MELANIE PLACE ESTATES SUBDIVISION

Engineering Comments: FINAL PLAT COMMENTS (should be addressed prior to submitting the FINAL PLAT for review and/or signature by the City Engineer):

APPLICATION NUMBER 4 DATE January 19, 2017

DETAIL SITE PLAN

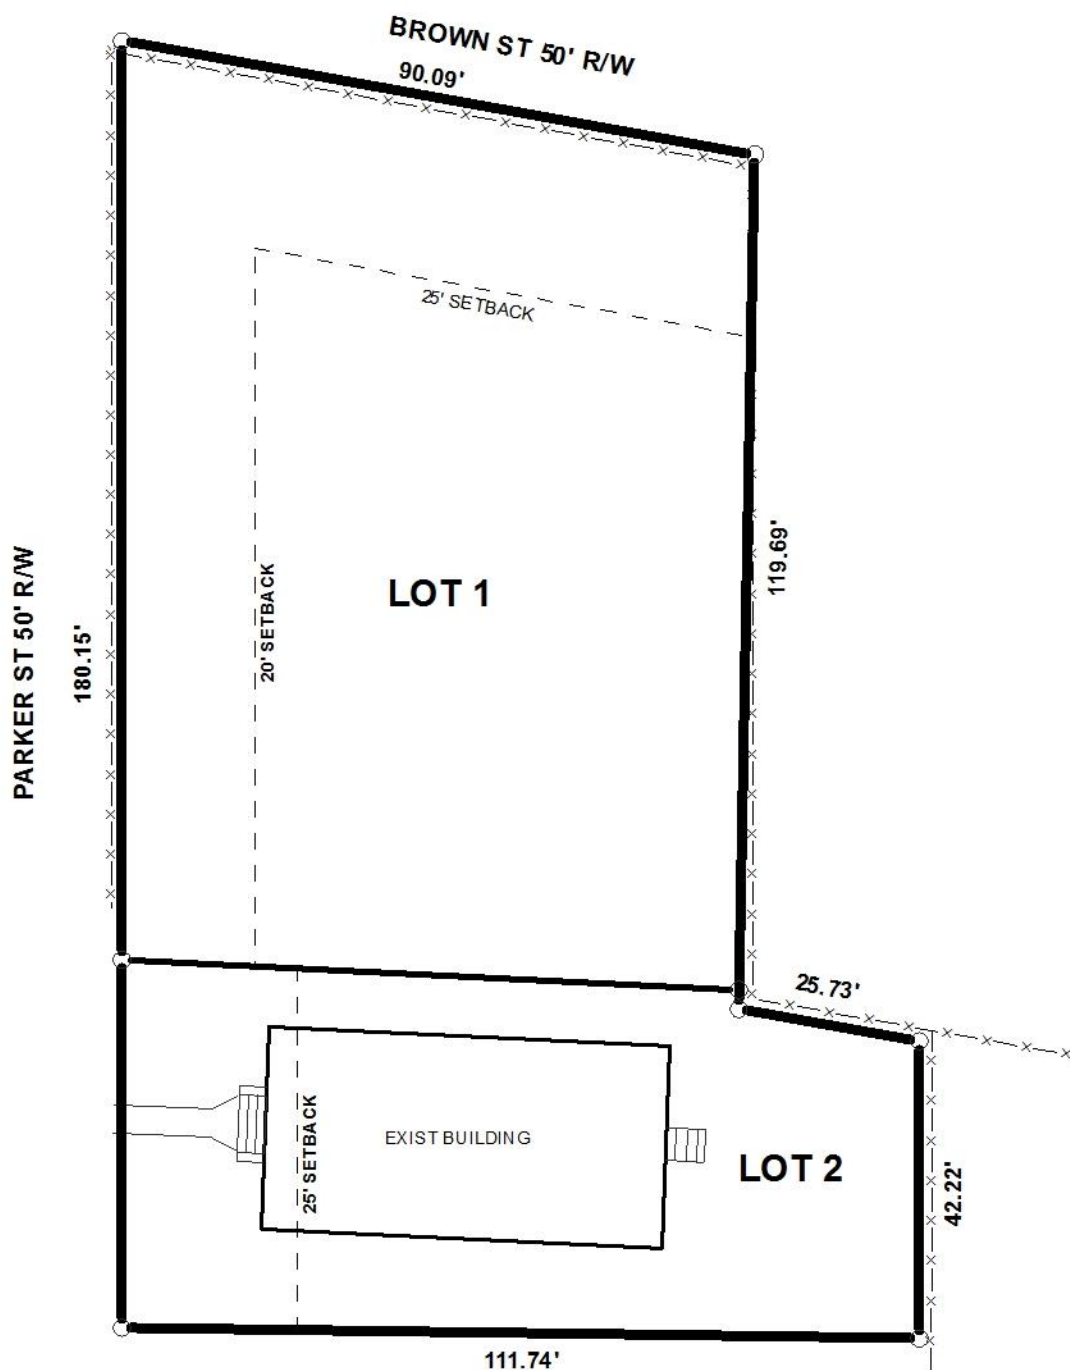
The proposed Lot 1 fronts Brown Street and Parker Street; both of which are minor streets with curb and gutter. The proposed Lot 2 fronts Parker Street. As minor streets, Brown Street and Parker Street require a 50' right-of-way width as depicted on the preliminary plat. If approved, the 50' right-of-way widths should be retained on the Final Plat. The preliminary plat does not illustrate dedication of the corner radii as per Section V.D.6. of the Subdivision Regulations. If approved, the Final Plat should be revised to provide corner radii dedication for Brown Street and Parker Street.

A 25-foot minimum building setback line is depicted on the preliminary plat along Brown Street for Lot 1, as well as a 20-foot minimum building setback depicted along Parker Street. It should be noted that reduced side yard setbacks along Parker Street would require a waiver of Section V.D.9. of the Subdivision regulations. Section V.D.9. of the Subdivision Regulations requires a 25' building setback; however, Section 64-4.D.3. of the Zoning Ordinance allows for reduced setbacks for a side street on a corner lot. If approved, the depicted setbacks should be retained on the Final Plat. Lot 2 illustrates an existing dwelling encroaching in the 25-foot building setback as illustrated on the preliminary plat. Section 64-3.G.3.a.(1) of the Zoning Ordinance states the following in regards to front yard setbacks in Historic District Overlays: *"The front yard setback shall be no greater or lesser than the setback of those structures on the same side of the street within 150 feet of both sides (exclusive of right-of-way) of the proposed building site"*. The dwelling immediately to the South of the site appears to be in line with the existing dwelling on the proposed Lot 2, therefore the setback could be revised to be in line with the existing dwelling. If approved, the 25' setback should be retained on the Final Plat.

The proposed Lot 1 depicted as 10,763.14± square feet which exceeds the 7,200 square foot minimum lot size requirements for lots served by public water and sanitary sewer systems; however, Lot 2 is depicted at 5,458.29± square feet and therefore does not meet the 7,200 square foot minimum lot requirement. It should be noted that the proposed Lot 1 could be reduced in size to allow Lot 2 to meet the 7,200 square foot requirement. However, as previously stated, the

site is in a Historic District, and substandard lots are not out of character in the area, making a waiver of Section V.D.2. of the Subdivision Regulations appropriate. The preliminary plat provides the lot sizes in square feet and acres. If approved, the lot size information should be depicted in both square feet and acres on the Final Plat.

The preliminary plat states “Lot one is limited to two curb cut with size location and design to be approved by Traffic Engineering and conform to AASHTO Standards, Lot 2 to use existing curb cut”. If approved, this should be revised to match Traffic Engineering comments on the Final Plat.

- 1) Retention of the 25' minimum building setback line along Brown Street;
- 2) Retention of the 20' minimum building setback line for Lot 1 along Parker Street;

- 3) Retention of the 25' minimum building setback line for Lot 2 along Parker Street;
- 4) Retention of 50' right-of-way width for both Parker Street and Brown Street;

- 5) Dedication of the corner radius to Parker Street and Brown Street;
- 6) Retention of lot size information in both square feet and acres adjusted for dedication;

- 7) Placement of a note on the Final Plat stating that each lot is limited to one curb cut per street frontage, with any changes in the size, design and location to be approved by Traffic Engineering and conform to AASHTO standards.
